Project	IEEE 802.16 Broadband Wireless Access Working Group < http://ieee802.org/16 >	
Title	A common SYNC symbol design for OFDMA	
Date Submitted	2004-08-24	
Source:	<p>Jason Hou, Jing Wang, Sean Cai, Dazi Feng, Yonggang Fang</p> <p>ZTE San Diego Inc. 10105 Pacific Heights Blvd. San Diego, CA 92121 USA</p>	<p>Voice: +82-31-279-3355 jiho.jang@samsung.com wonil.roh@samsung.com sjmaeng@samsung.com panyuh@samsung.com jhjeon@samsung.com soon.young.yoon@samsung.com seongwook.song@samsung.com</p> <p>Voice: 858-554-0387 Fax: 858-554-0894 jhou@ztesandiego.com jwang@ztesandiego.com scai@ztesandiego.com dfeng@ztesandiego.com yfang@ztesandiego.com</p>
Re:	IEEE 802.16e D4 Draft	
Abstract	Addition of a common SYNC symbol to aid in fast cell search.	
Purpose	To incorporate the changes here proposed into the 802.16e D5 draft.	
Notice	This document has been prepared to assist IEEE 802.16. It is offered as a basis for discussion and is not binding on the contributing individual(s) or organization(s). The material in this document is subject to change in form and content after further study. The contributor(s) reserve(s) the right to add, amend or withdraw material contained herein.

A Common SYNC S

Figure X. Common SYNC symbol basic structure

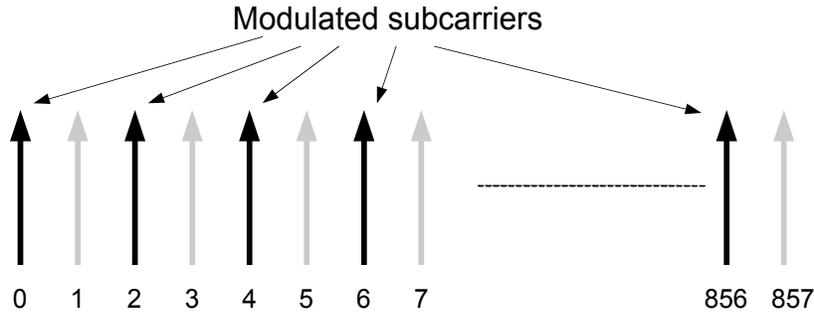
The common SYNC symbol modulates each 2'nd subcarrier with modified CAZAC sequences and uses legacy preamble boosting formula described in 8.4.9.4.3.1. Figure X depicts an example of the subcarrier modulation.
